Appl. No. 10/086,862

Amdt. Dated February 12, 2004

Reply to Office action of Nov. 19, 2003 & Jan. 12, 2004

Appl. No. 10/086,862
Amdt. dated February 12, 2004
Reply to Office action of November 18, 2003
Annotated Sheet Showing Changes

FIG. 1

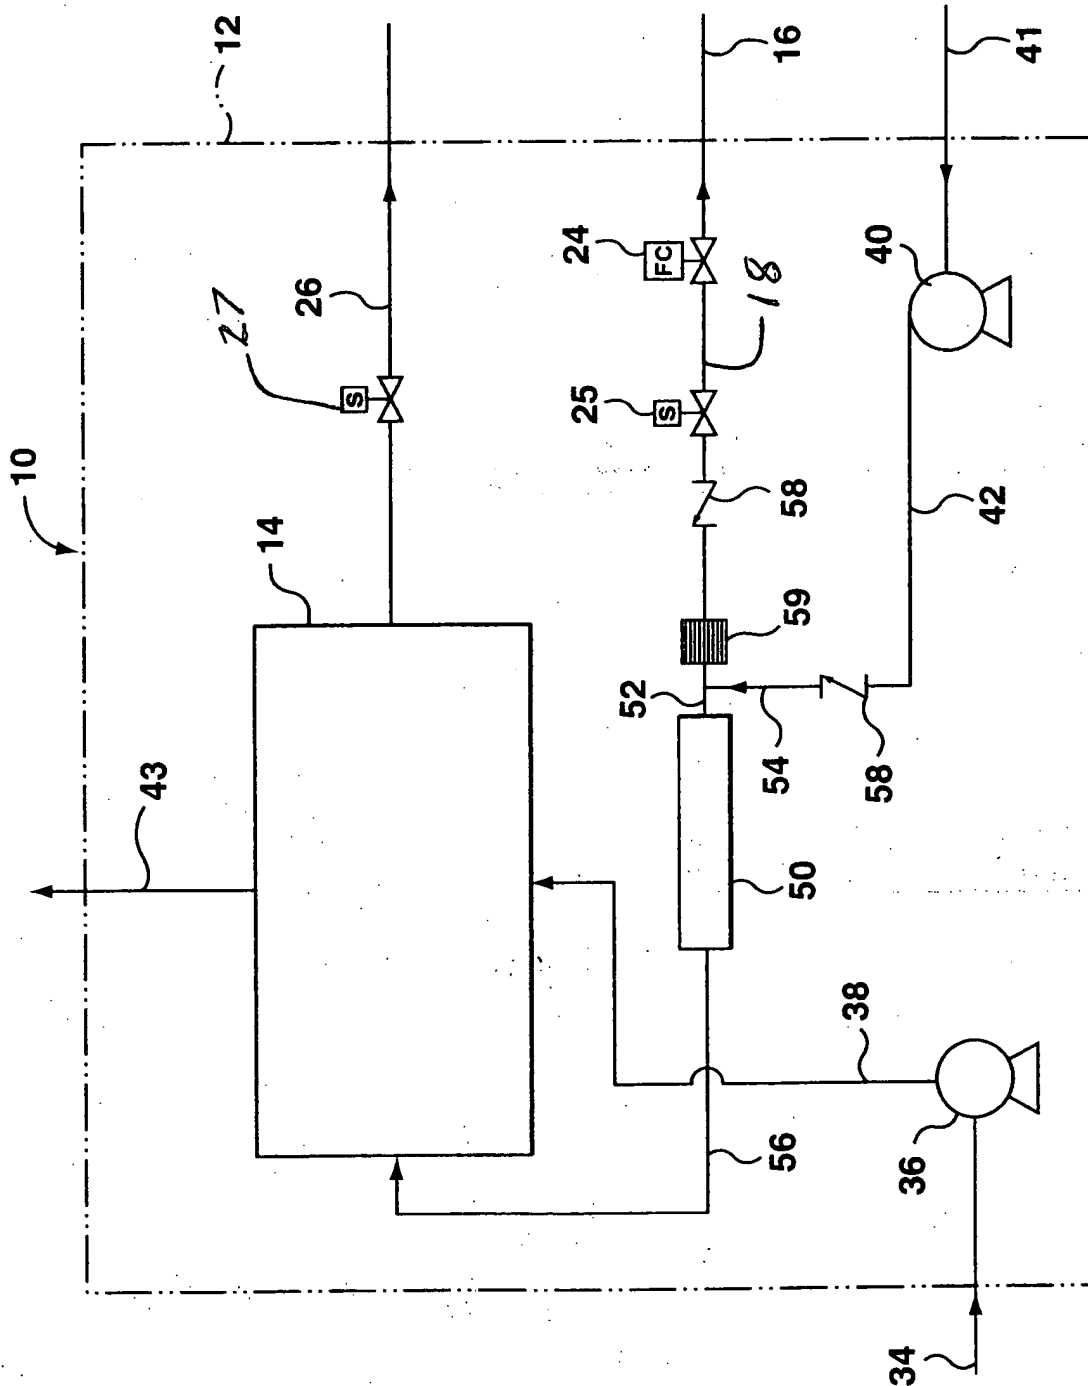
The Examiner's acknowledgement of the information disclosure statements is noted. With respect to the drawings, the Examiner noted, correctly, that the reference numerals 18, 27 were missing from Figure 1. Attached are formal

drawings showing a proposed amendment to include references 18 and 27. These drawings include legible reference numerals. No new matter has been added.
